STAFF REPORT

Subject: Jerde Single Family Dwelling Addition; 192 Foothill Drive; Zephyr Cove, Douglas County, NV; Assessor's Parcel Number (APN) 1318-10-310-045; TRPA File Number ERSP2023-0906

DRAFT PERMIT

Site Plan

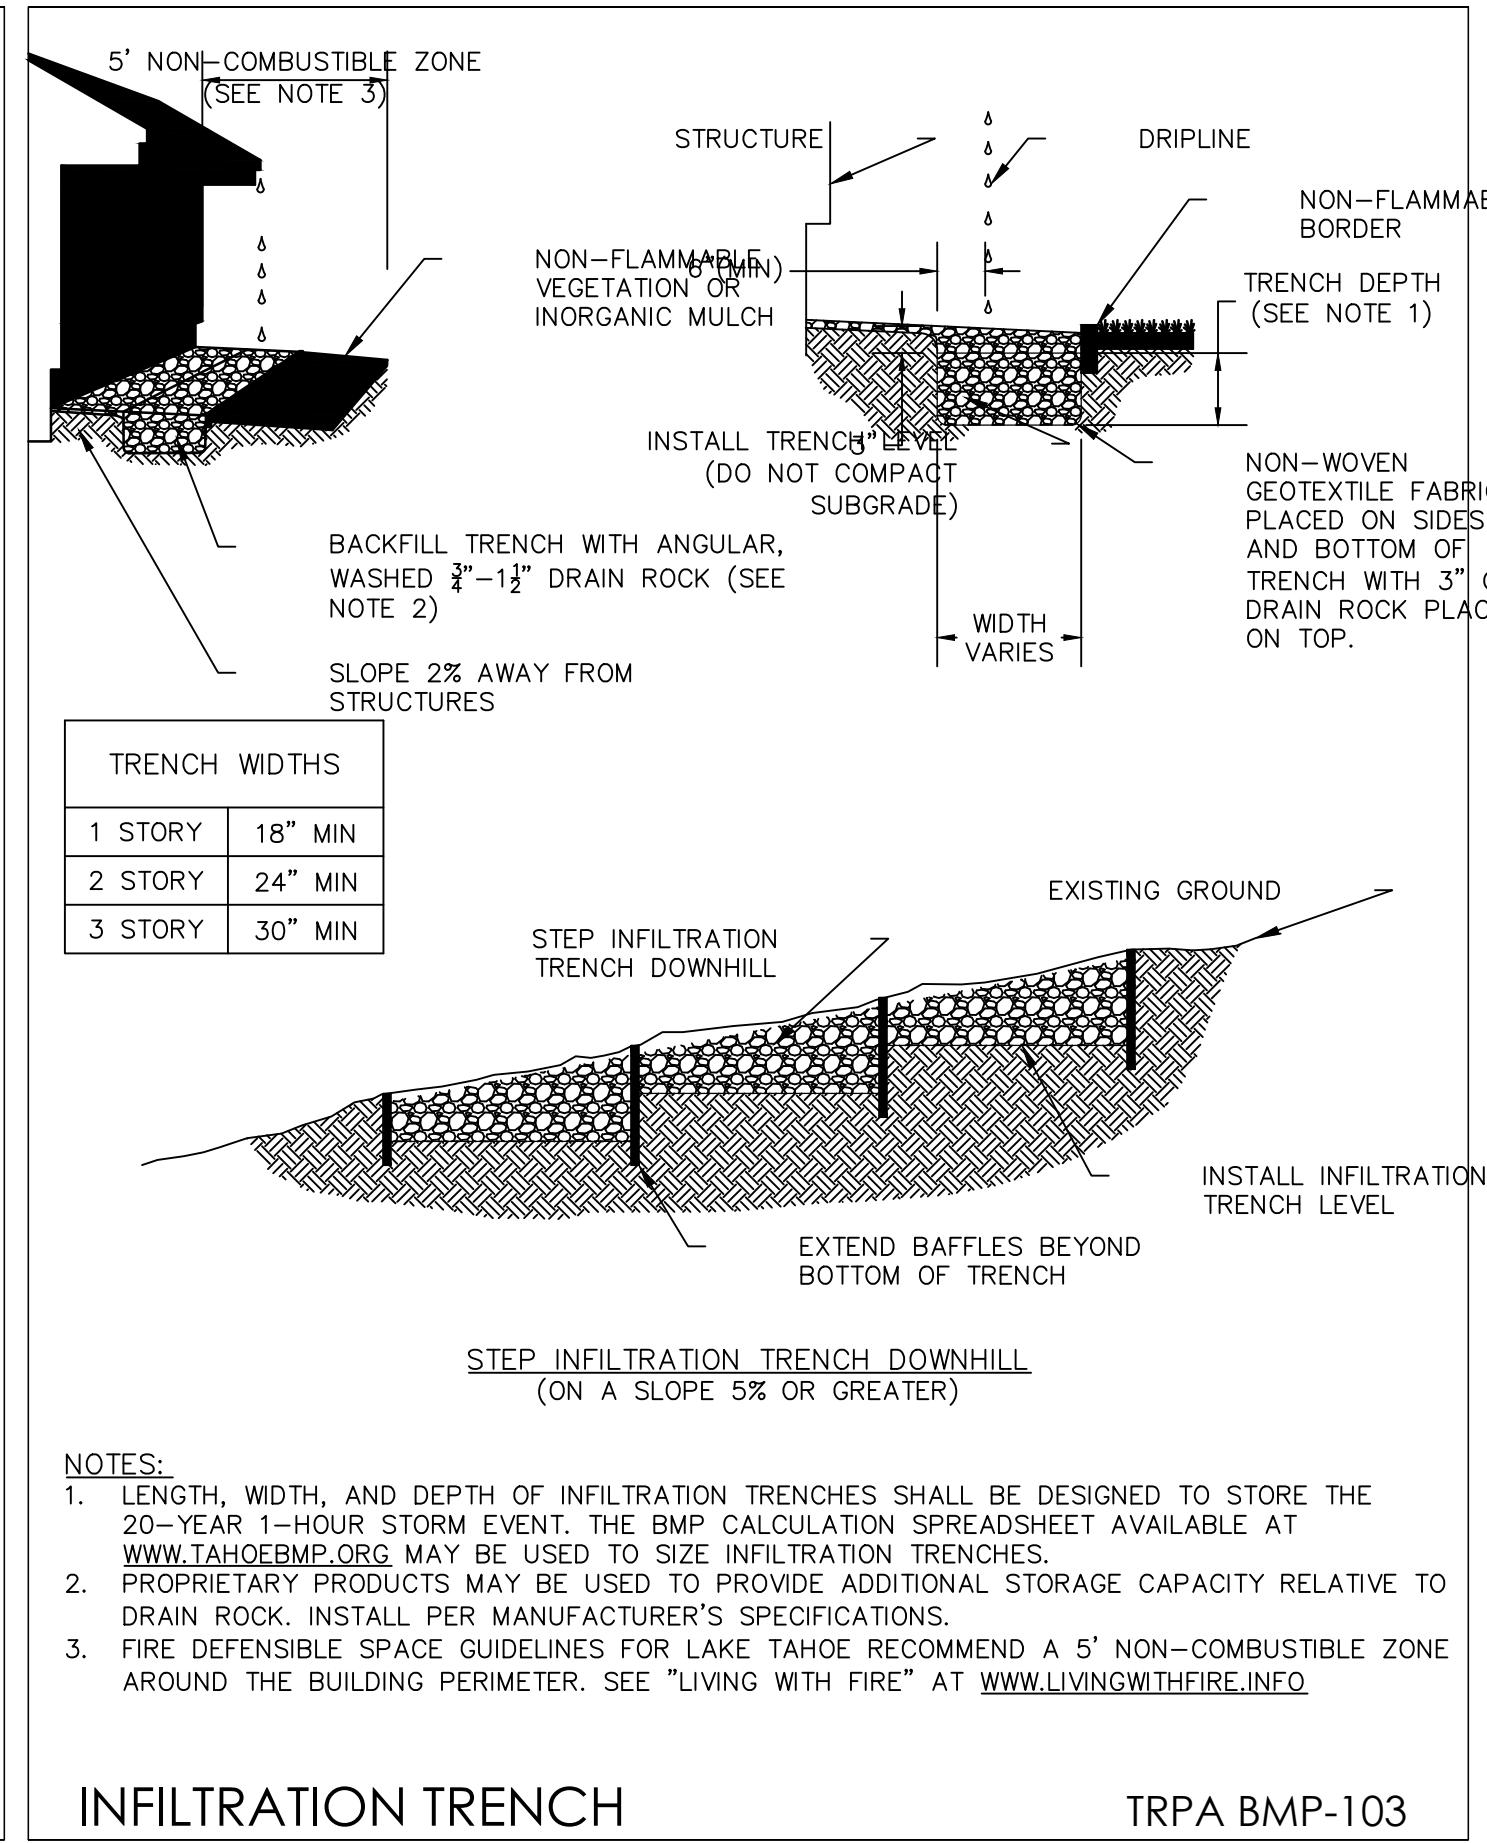
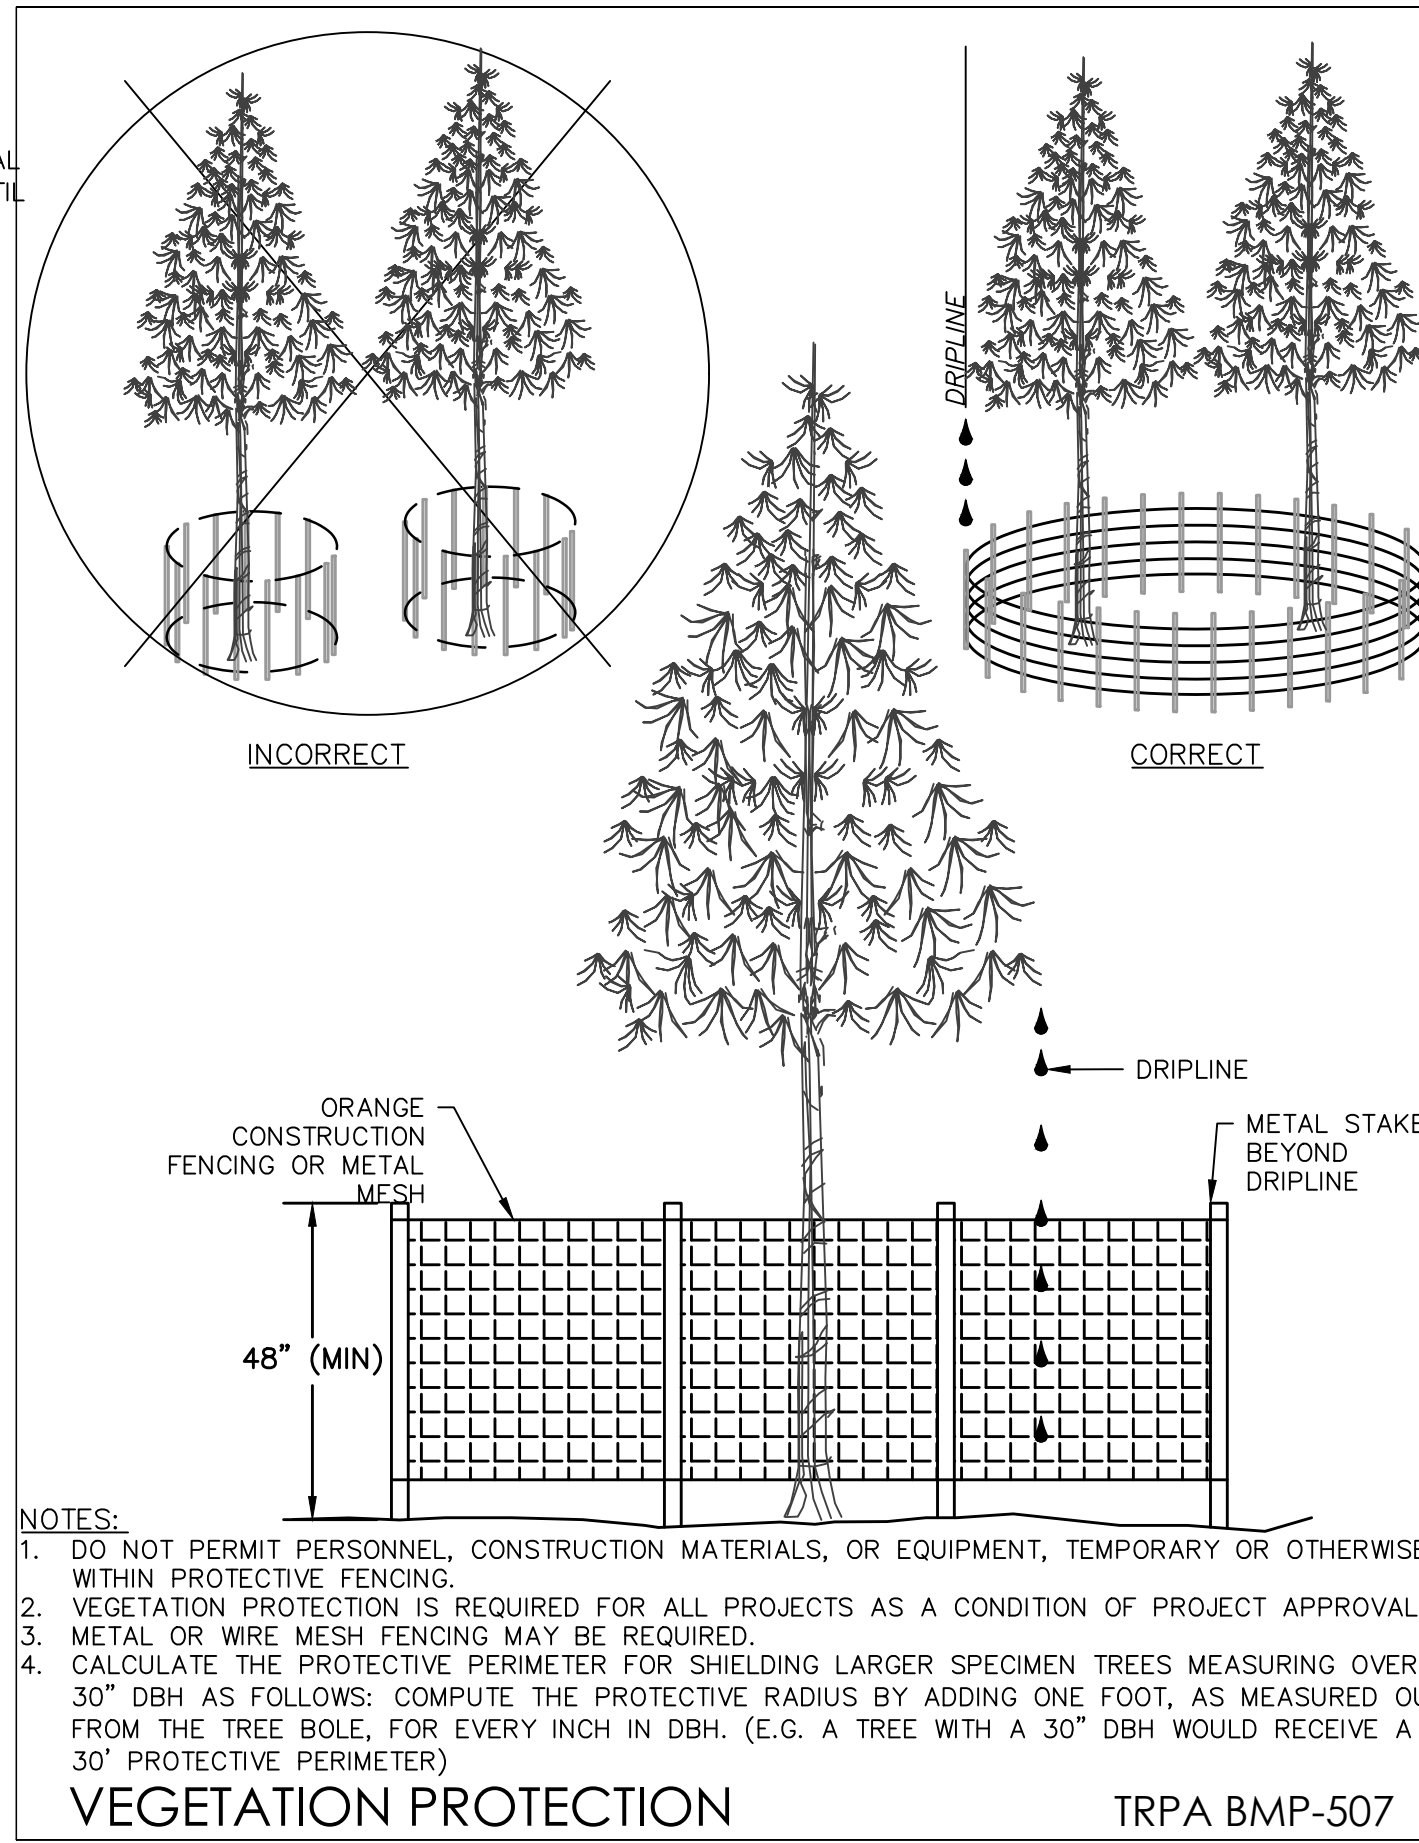
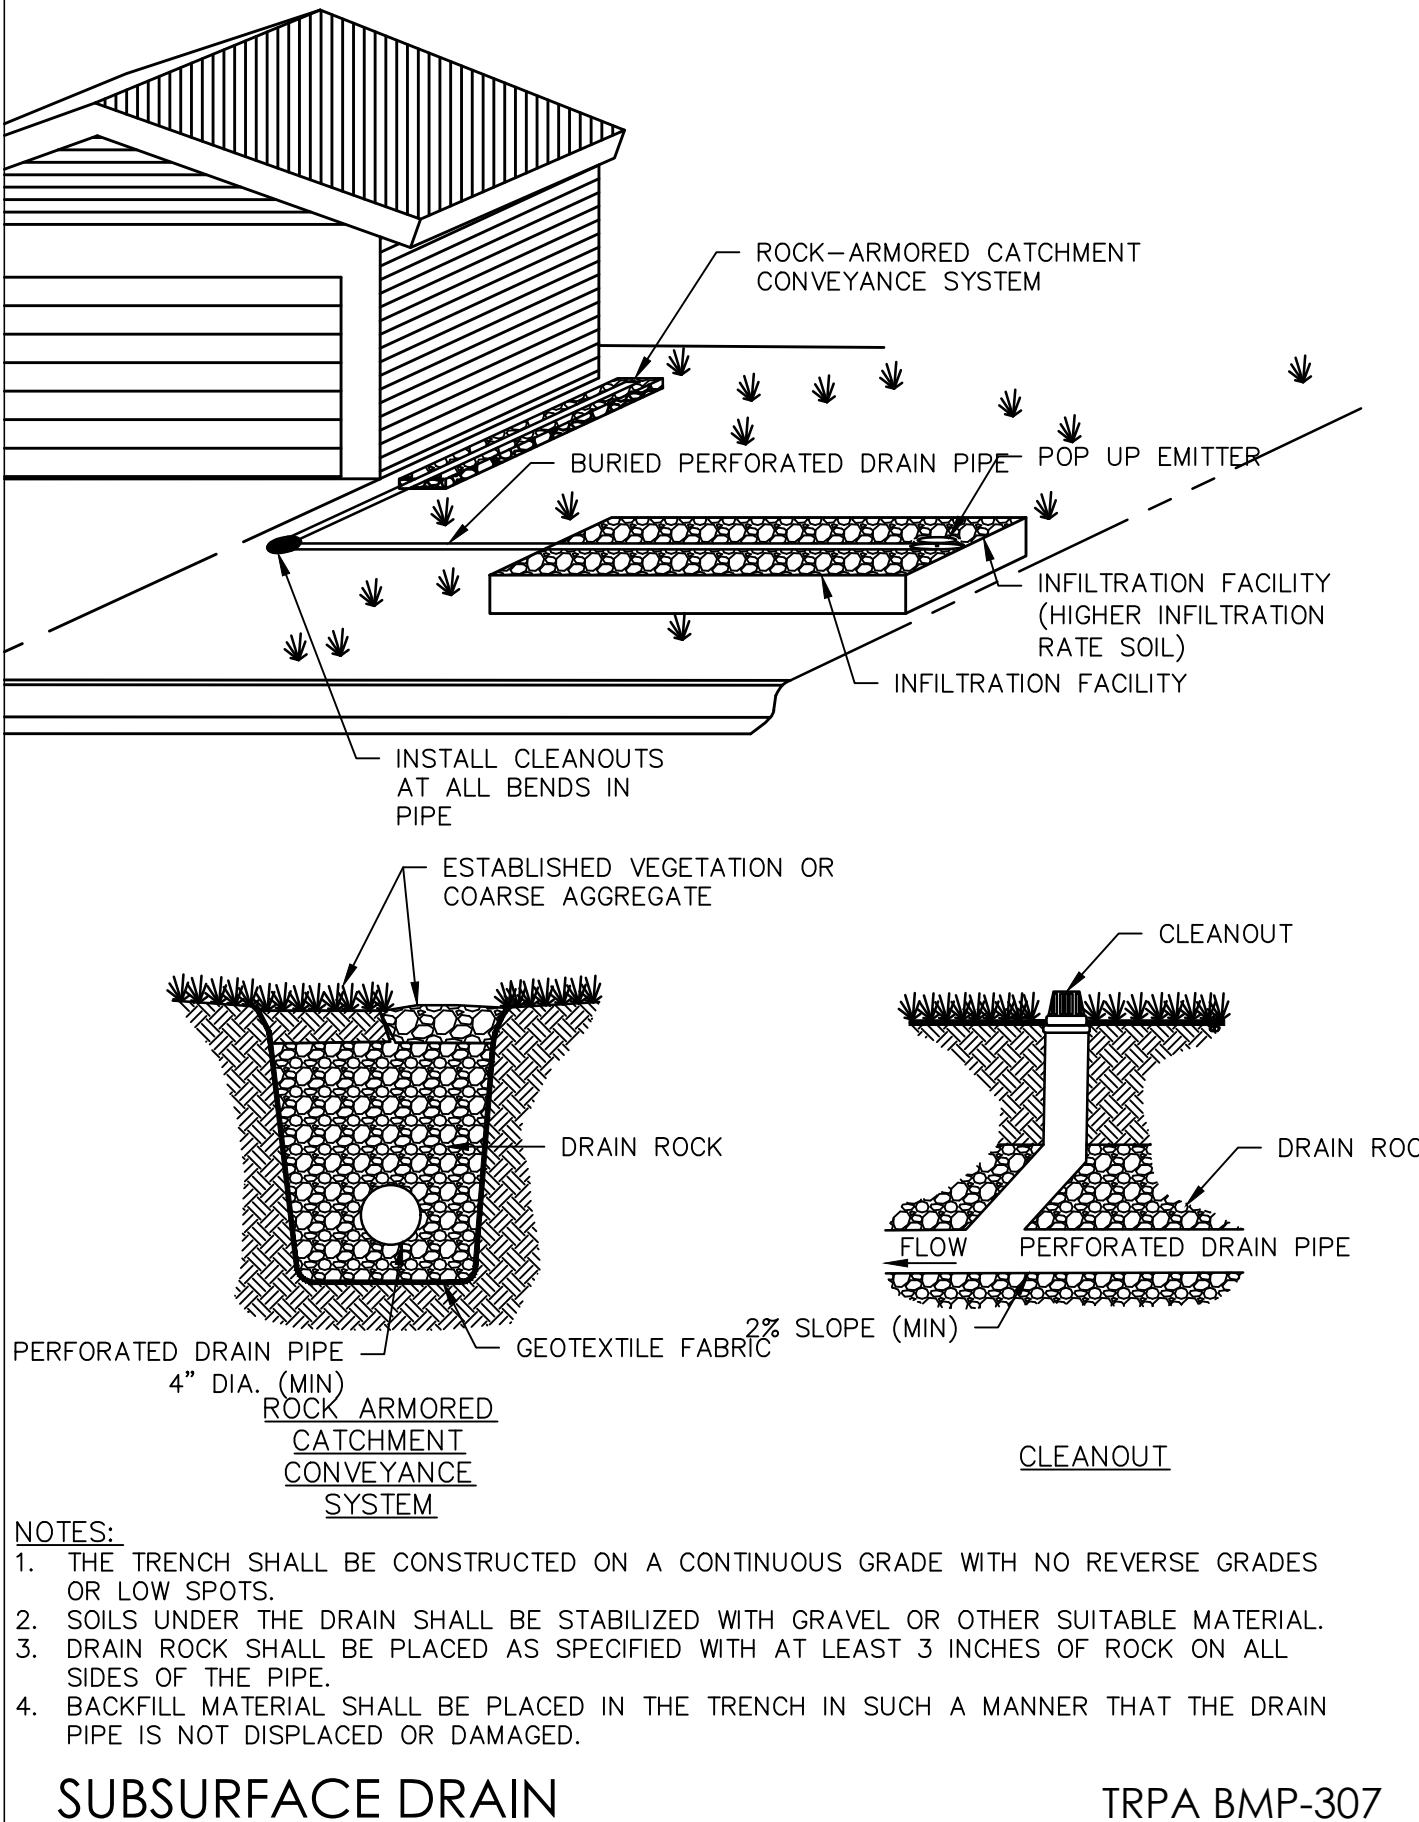
2. The Standard Conditions of Approval listed in Attachment R shall apply to this permit.
3. Prior to permit acknowledgement, the following conditions of approval must be satisfied.
 - A. The site plan shall be revised to include:
 - (1) The following revised proposed land coverage calculations:

Main House	900 sf
Deck w/3:1 Height Reduction	370 sf
Wood Platform & Steps	192 sf
Shed	120 sf

Concrete Pad/Patio	76 sf
<u>Concrete Driveway</u>	<u>690 sf</u>
Total Proposed Coverage	2,348 sf
Banked Coverage	251 sf
Remaining Potential Coverage	491 sf

- (2) Slope calculation across the building site, as described in TRPA Code Section 37.3.3 and Figure 37.3.3-A.
 - (3) Location and elevation of the proposed low point of the structure for calculation of proposed height.

- (4) Location of all existing/proposed utility lines.
 - (5) No trees are approved to be removed with this project. Revise plan to remove indication of trees to be removed.

- (6) Proposed permanent BMPs and BMP infiltration calculations for the existing shed and tent platform.
 - (7) Vegetation protective fencing around the entire construction site. The fencing shall be no more than 12 feet from any footprint, driveway, or area of approved disturbance. Trees located within the construction area that are to be retained shall be individually protected by fencing beyond the drip-line of the outermost branches, or by other means if approved by the TRPA Inspector. No equipment, personnel or disturbance is allowed within the areas protected by the vegetation fencing.

- (8) Parking barriers to restrict parking to approved parking surfaces only.
- B. The elevations shall be revised to include corrected allowed and proposed height calculations based on the revised slope across the building site and the identified new low point of the structure.
